**SECTION 4.55(2) MODIFICATION OF DEVELOPMENT CONSENT**

**ADDRESS:** 23-29 HARVEY AVENUE, MOOREBANK, 2170  
LOT 28, DP 236405

**DESCRIPTION:** Modification to development consent DA-6/2018 under Section 4.55(2) of the Environmental Planning and Assessment Act 1979, for internal and external alterations and additions.

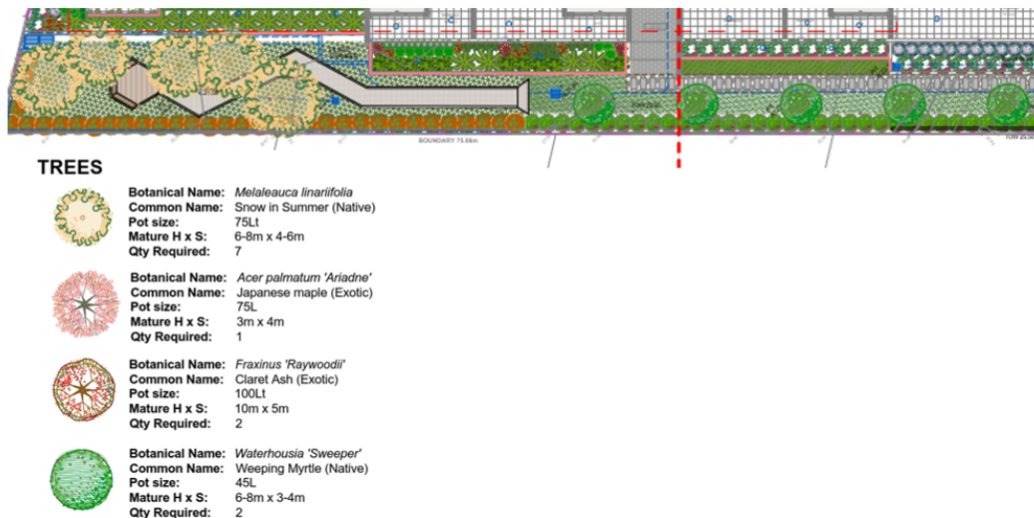
As shown in the below site plan from Endeavour Energy's G/Net master facility model (and extract from Google maps Street View) there are:

- No easements over the site benefitting Endeavour Energy (active easements are indicated by red hatching).
- Low voltage and 11,000 volt / 11 kV high voltage overhead power lines to the road verge / roadway.
- Low voltage overhead service conductors from the poles on the road verge to the customer connection points for the existing dwellings.

#### A4.3 - Padmount easements and clearances

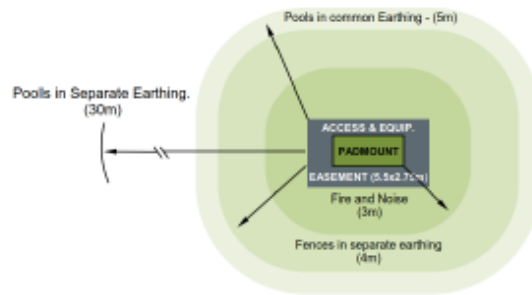
As shown in the following extract of Endeavour Energy's Mains Design Instruction MDI 0044 'Easements and Property Tenure Rights', Figure A4.3 'Padmount easements and clearances', padmount substations require:

- Easement with a minimum size of 2.75 x 5.5 metres (single transformer).
- Restriction for fire rating which usually extends 3 metres horizontally from the base of the substation footing / plinth.
- Restriction for swimming pool or spa which extends 5 metres from the easement.

The easement should not cross property boundaries but the restriction/s may affect any adjoining property provided they are able to be registered on the title to that property. In addition the following matters also need to be considered in regard to the fire restriction:

- Personnel access doors and fire exit doors to a building are not permitted within the fire restriction area.
- Gas mains/pipes shall not pass through the fire restriction area.
- A 10 metre clearance distance shall be maintained between substation and fire hydrants, booster valves, and the like in accordance with AS2419.1 'Fire hydrant installations System design, installation and commissioning' as updated from time to time.
- Any landscaping that potentially could transfer / provide connectivity for flame or radiant heat from a fire in the substation to a dwelling or building should be avoided.
- The storage of and / or use of flammable, combustible, corrosive or explosive material within the fire restriction should be avoided.

Generally it is the Level 3 Accredited Service Provider's (ASP) responsibility (engaged by the developer) to make sure padmount substation location and design complies with Endeavour Energy's standards the suitability of access, safety clearances, fire ratings, flooding etc.

As a condition of the Development Application consent Council should request the submission of documentary evidence from Endeavour Energy confirming that satisfactory arrangements have been made for the connection of electricity and the design requirements for the substation, prior to the release of the Construction or Subdivision Certificate / commencement of works.

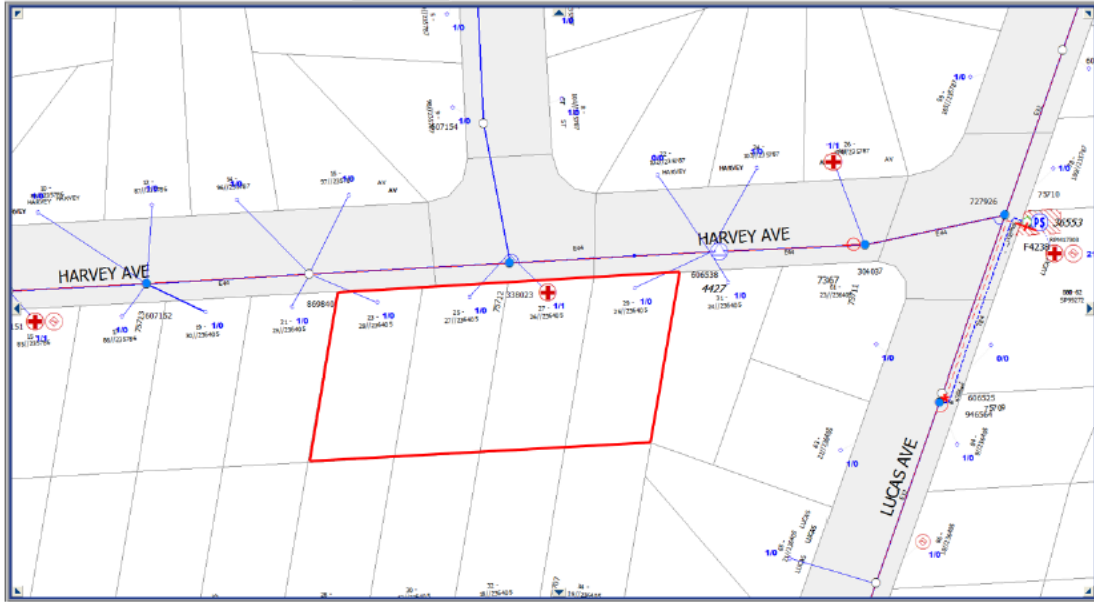
The Section 4.55 (2) Modification Report indicates the modifications include 'Provide a substation at the northeast corner of the site' which is shown in the following extracts of the Architectural Plans.
